Site Accessibility Evaluation

**Citadel Transfer Station
PU18-0081**

SUBJECT: Citadel Transfer Station Self-Evaluation

Image of curb head without curb ramp

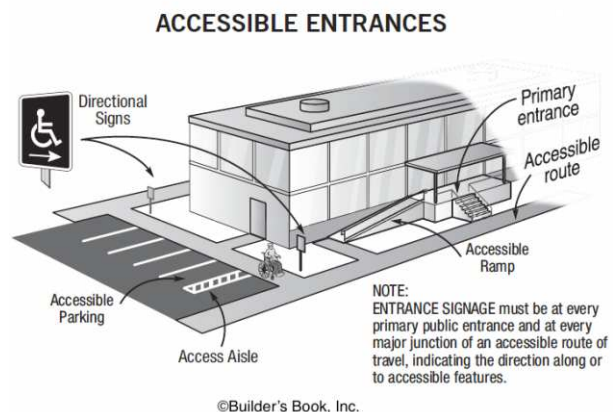
Finding: 1

There is no accessible route of travel from the public way. This is a primary entrance point to the Transfer Station.

There is not a connecting ramp at Chelton and W. Portal.

Install a curb ramp at this corner.

Image of sidewalk abruptly ending

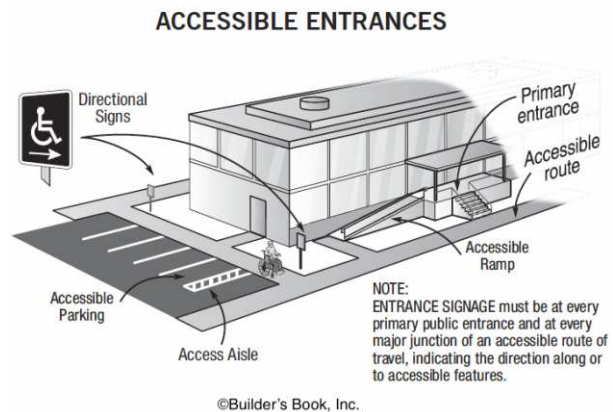
Finding: 2

There is no accessible route of travel from the public way.

The sidewalk abruptly ends near Chelton Rd and W. Portal.

Probably nothing at this time. Consider sidewalk construction.

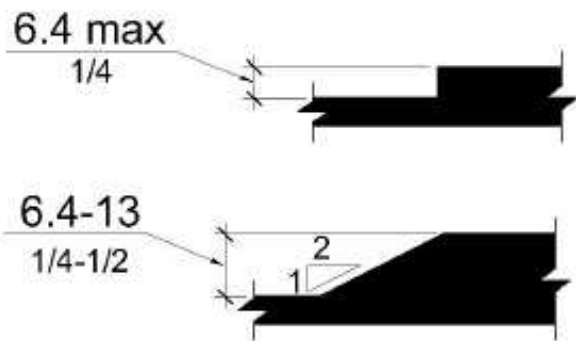
Finding: 5

The surface of the pedestrian access route has vertical discontinuities greater than 1/2 inch or between 1/4 inch and 1/2 inch that are not beveled.

There is 1-1/2" vertical displacement in the sidewalk at the storm inlet.

Remove and replace the sidewalk panels around the storm inlet.

Image of accessible parking spaces without signage

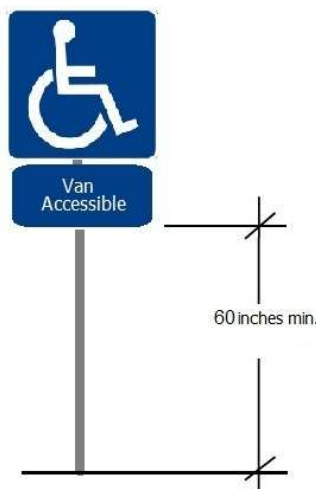
Finding: 7

The required parking signage is missing.

Accessible parking signage is missing on two of the accessible parking spaces.

Install accessible parking signage.

Image of accessible parking without signage

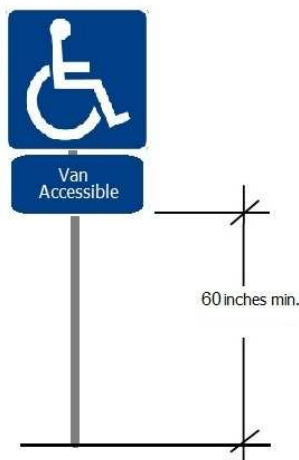
Finding: 8

The required parking signage is missing.

One of the parking spaces has a post but no sign.

Install an accessible parking sign.

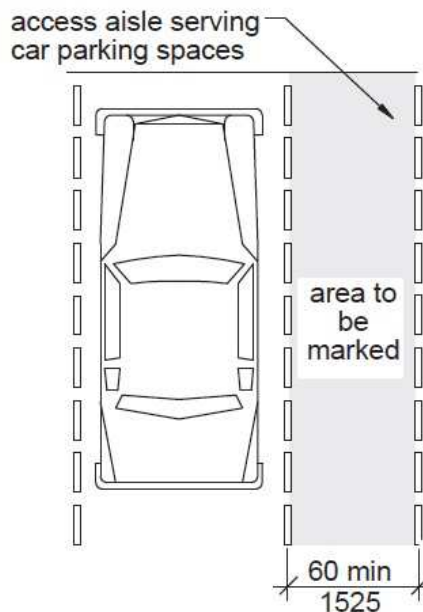
Finding: 10

The access aisle is not a minimum 5 feet wide.

One of the access aisles is 4'-6" wide.

Restripe the parking and access aisle to provide a 5'-0" wide access aisle with 8'-0" wide parking space.
